# **Annual Monitoring Report**

Monitoring Year 3 of 7

Pee Dee Stream Restoration Project

RE: Pee Dee Stream Restoration Site: MY3 Monitoring Report (NCDMS ID 95350)

- ▭ Conservation Easement
- ⊕ Crest Gauge
- ⊙ Rain Gauge
- Cross Section
- ★ Photo Station
- Stream Structure
- Top of Bank
- Restoration
- Enhancement I
- Vegetation Plot Success**
- Met

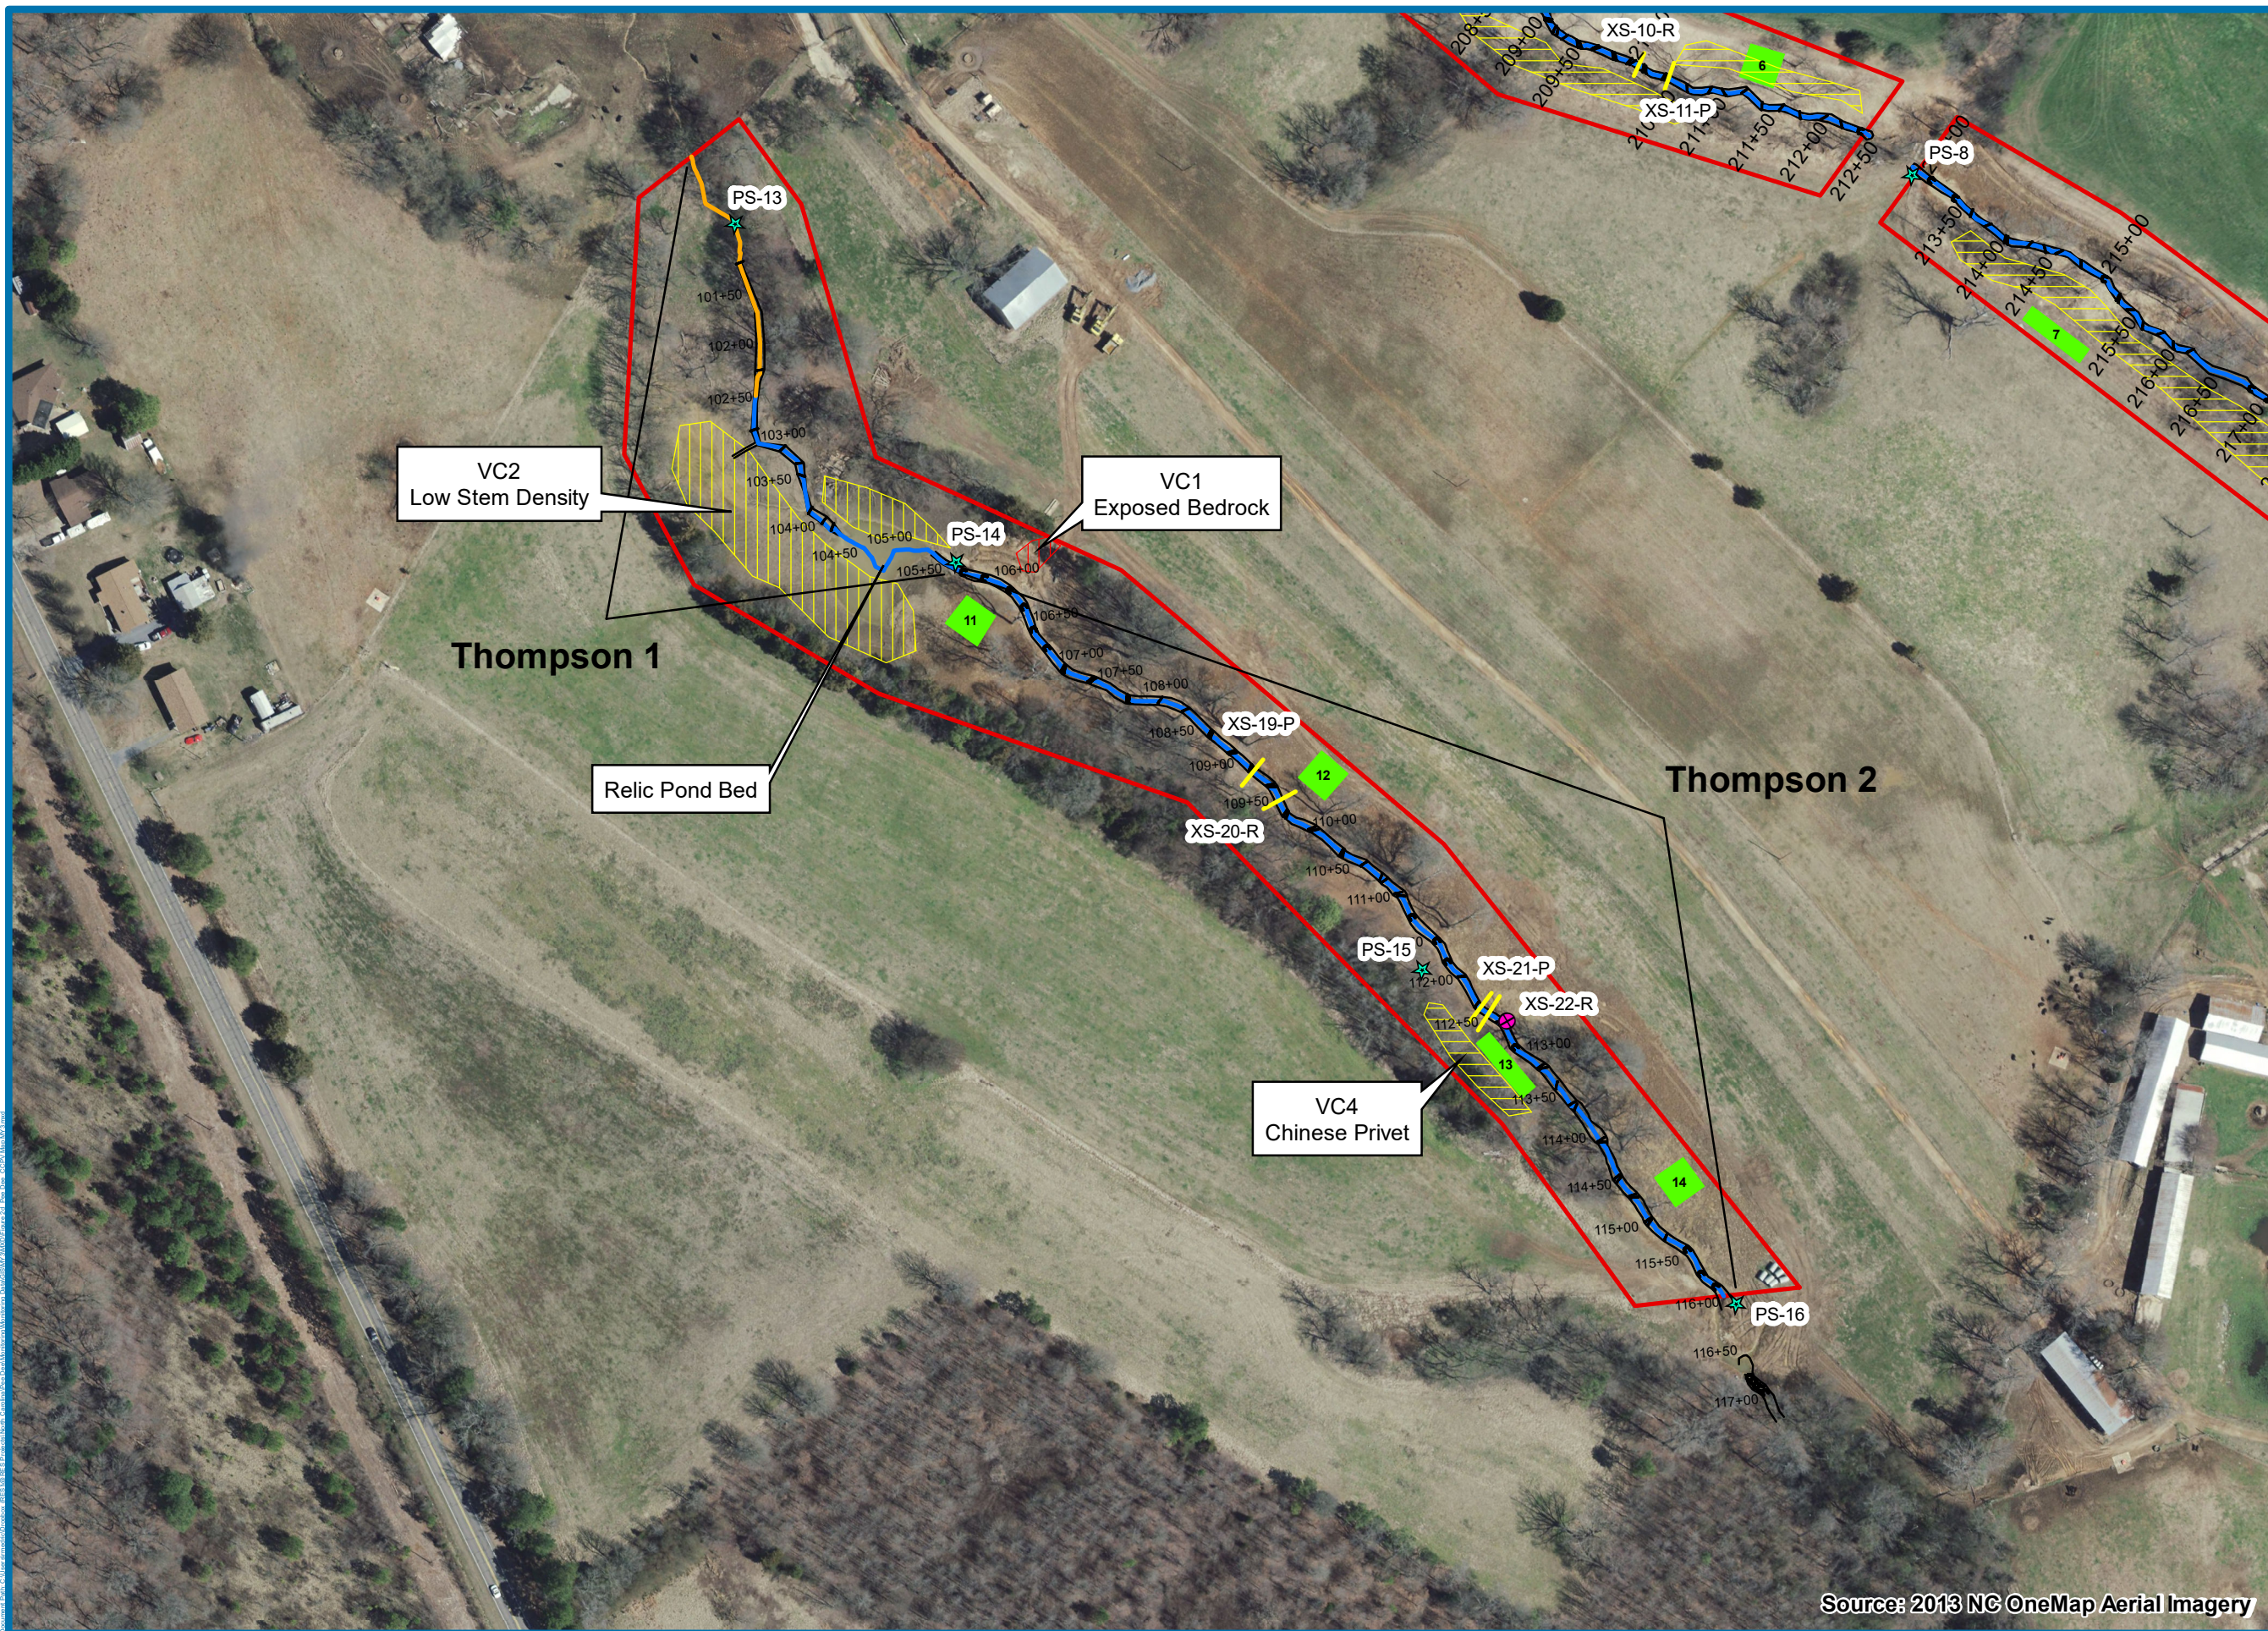
When CCPV is folded out, the Jerry Branch map appears upside down; also cross section tables, etc. Even though this is not a problem in the digital PDF, sheets should not appear upside down when the hard copy report is read.

It would be helpful to show major station breaks on the CCPVs.

Landscape printing issues have been corrected in the Final Report.

Done.
